City of Pensacola

Architectural Review Board

Agenda - Final

Thursday, October 19, 2023, 2:00 PM

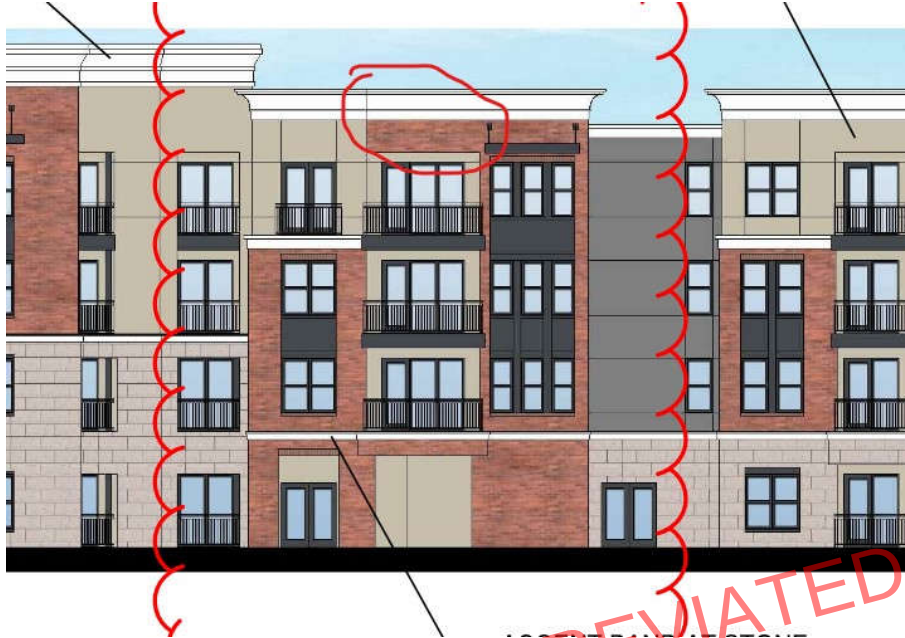
1. Reference sheet L1.24. The corner of the building adjacent to the North side of the garage entrance appears to conflict with the existing historic wall which is to remain.
 - a. Provide clarification on how the existing historic wall will not be compromised.
2. Some of the paver materials are different from the final (Wausau Tile P-102 & P-103 were not in the last submittal, Paver type 7 is different, and P-112 appears to be new also). The Wausau tiles have prominent locations.
 - a. Please provide additional information on this material and pattern.
3. Many of the plantings appear to have changed.
 - a. Please provide graphic information on the new plantings (similar format to the information provided during the final review). Specifically for Camellia, Oakland Red Holly, Cast Iron Plant, Carissa Chinese Holly, Big Blue Liriope, Giant Boarder Grass, Mondo Grass, Shrubby Yew

current element is too diminished

- c. There is another area where it appears the lower level has expanded
 - i. Please provide additional information on the new condition.

1. Is the new area recessed from the wall to the North?
2. Does it have a roof? Eave trim?
